## ***VX-160EV/180EV Final FET upgrade modification***

Please apply following a temporally upgrade modification when you will have servicing to replace fault FET with **VX-160EV/180EV** for production lot between #25 and #44. After #45 all modification applied to production.

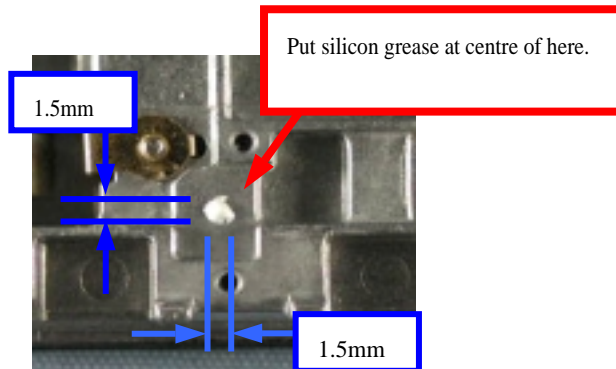
**1) Remove thermal sheet (RA0533600) form chassis**

**2) Put Silicon grease as follows**

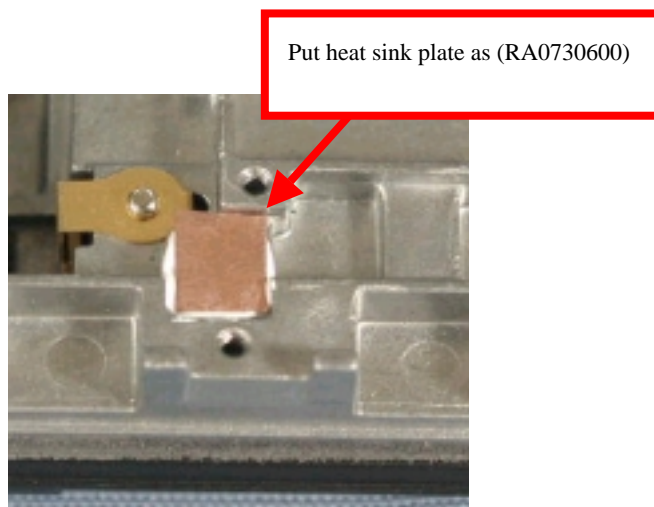
**3) Put heat sink plate**

Please make sure radio production lot number as following two heat sink plates.

Production lot # 45 and after should be applied RA0727570.

For # 25 to # 44: Please use heat sink plate as (RA0730600)
